BAMx Comments on the CAISO Draft 2013-14 Transmission Plan

The Bay Area Municipal Transmission group (BAMx)¹ appreciates the opportunity to comment on the CAISO Draft 2013-14 Transmission Plan (Draft Plan). The comments and questions below address the multiple *Draft Transmission Plan* studies, findings and recommendations included in the CAISO Draft 2013-14 Transmission Plan dated February 3, 2014 and were subsequently discussed during the February 12th stakeholder meeting. We request that the CAISO address these issues in its Revised Transmission Plan expected in March 2014.

Figure 1: Resources, by Category, to Meet the Need in 2013 in SONGS Study Area

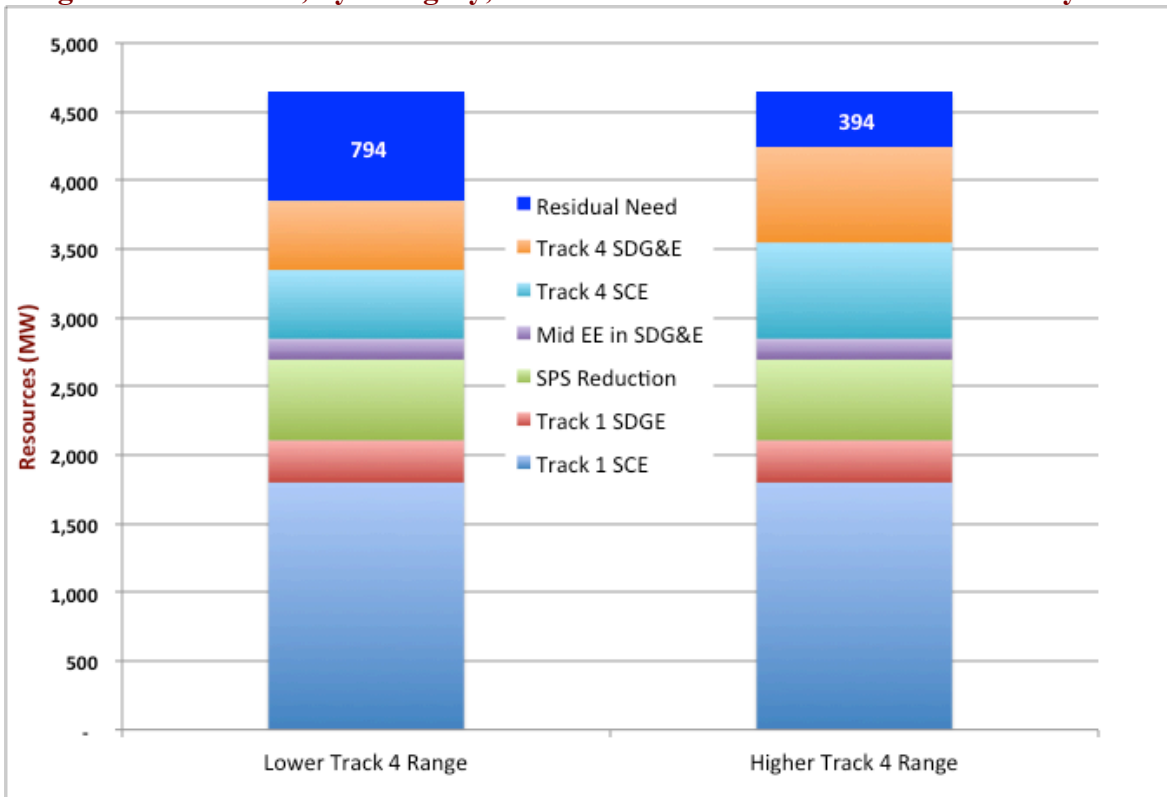
In Figure 1, we show how the current Track 1 and proposed Track 4 resource authorizations by the CPUC in 2012 LTPP proceeding stack up against the 4,642MW need identified for 2022/23 within the SONGS area⁸ identified by the CAISO. It shows a residual need of 394MW-794MW depending upon the level of Track 4 authorizations that can be met by a single *Group I* transmission project, i.e., Imperial Valley Phase Shifter, which is expected to provide local resource reduction benefit in the range of 400-840MW.⁹

Alternatively, the procurement authorized in the 2012 LTPP Track 1 and Track 4 could be supplemented by

- a) Procurement of additional preferred resources (beyond the assumptions used by the CAISO in Track 4 models) as anticipated in the Track 4 proposed decision; or
- b) Additional procurement authorized in future LTPP proceedings; or
- c) Potential delay in retirements of OTC plants to facilitate implementation of options (a) and/or (b).

Given the multiple options available to meet future residual resource need in the SONGS study area, the great strides that have been made in these procurement and transmission planning cycles, and the value in allowing time for market response to these steps, we urge the CAISO to delay the approval of projects beyond the Imperial Valley phase shifter at this time. Most questionable of the *Group I* projects appears to be the SCE proposed Mesa Loop-In project. With a benefit that can drop to as little as 226 MW¹⁰ and a cost of as much as \$614-700 million, this project does not fit a least regrets strategy and represents an unnecessary risk. It should be considered again in a later amendment or in next year's plan after full refinement of its expected cost and changes to its proposed configuration as identified by the CAISO.
